ADDITIONAL SHIELDING FOR THE RV-4/RV-3 REMOTE VFO

REMOTE VFO

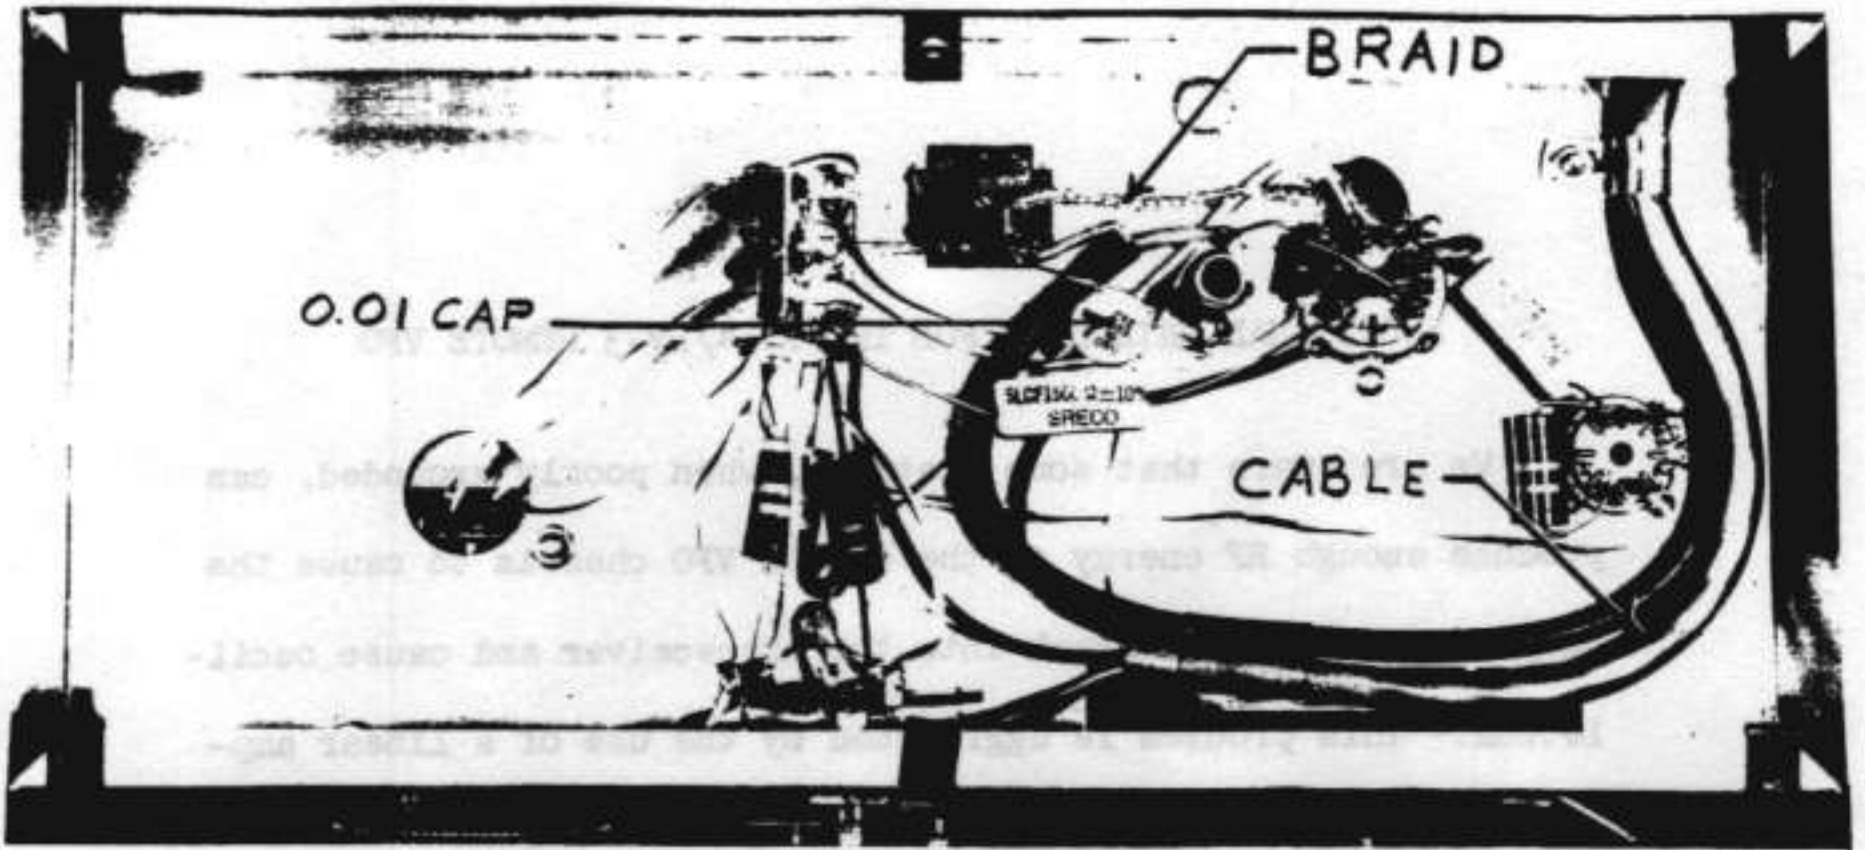
We are aware that some stations, when poorly grounded, can produce enough RF energy on the remote VFO chassis to cause the output signal to feed back into the transceiver and cause oscillation. This problem is aggravated by the use of a linear amplifier which not only increases the transmitted power but also increases gain in the feedback loop.

Since it is not always possible to get on effective RF ground to the station, additional shielding may be provided for the remote VFO.

1. Replace the original cable with the cable combination supplied. The same color scheme is used except that the brown lead in the new cable replaces the gray lead in the original cable.
2. Replace C18, a 0.005 capacitor with the 0.01 capacitor supplied
3. Replace the 2 1/2" B/W #22 ground wire with the 2 1/2" piece of 1/8" braid supplied.
(See pictorial)

To modify the RV-3 it is only necessary to replace the cable as described in step #1. Steps #2 and #3 do not apply.
